Economic and Social Council

Working Party on General Safety Provisions

Report of the Working Party on General Safety Provisions on its 129th session

Draft Amendments to UN Regulation No. 46 (Devices for Indirect Vision)

Figure 1a

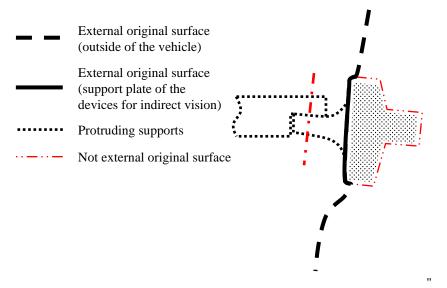
Figures 1 (former), renumber as figures 1b to 1c

Figure 1c

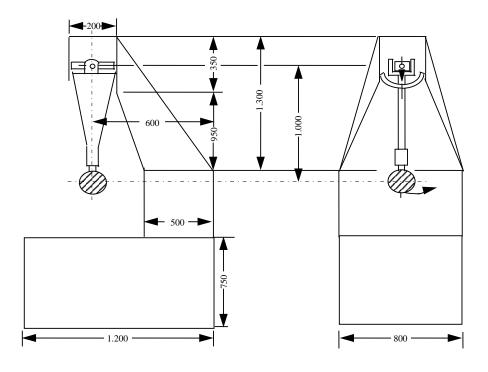
Figure 1c below gives the dimensions (in mm) of the test rig and the special design specifications:

Figure 5 Class II fields of vision

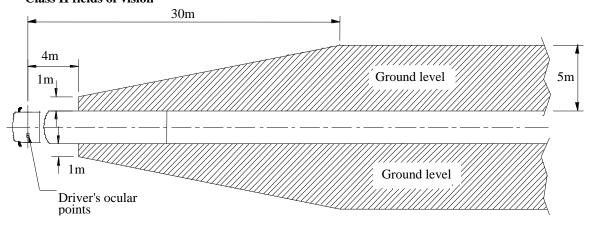
In addition, the road shall be visible to the driver over a width of 1 m, which is bounded by a plane parallel to the median longitudinal vertical plane and passing through the outermost point of the vehicle starting from a point 4 m behind the vertical plane passing through the driver's ocular points, **while**

linearly increasing up to a width of 5 m wide at the point 30 m behind the vertical plane passing through the driver's ocular points (see Figure 5).

Figure 6 Class III fields of vision

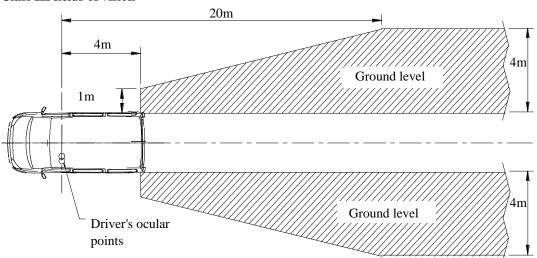
The field of vision shall be such that the driver can see at least a 4 m wide, flat, horizontal portion of the road, which is bounded by a plane parallel to the median longitudinal vertical plane and passing through the outermost point of the vehicle on the driver's side of the vehicle and extends from 20 m behind the driver's ocular points to the horizon (see Figure 6).

In addition, the road shall be visible to the driver over a width of 1 m, which is bounded by a plane parallel to the median longitudinal vertical plane and passing through the outermost point of the vehicle starting from a point 4 m behind the vertical plane passing through the driver's ocular points, while linearly increasing up to a width of 4 m wide at the point 20 m behind the vertical plane passing through the driver's ocular points.

Figure 7 **Class IV fields of vision**

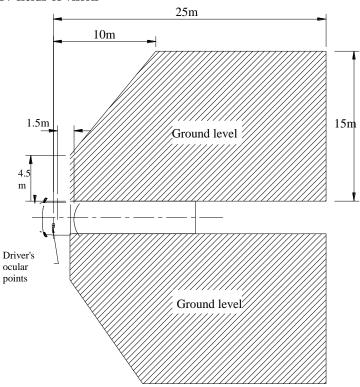
In addition, the road shall be visible to the driver over a width of 4.5 m, which is bounded by a plane parallel to the median longitudinal vertical plane and passing through the outermost point of the vehicle starting from a point 1.5 m behind the vertical plane passing through the driver's ocular points, while linearly increasing up to a width of 15 m wide at the point 10 m behind the vertical plane passing through the driver's ocular points (see Figure 7).
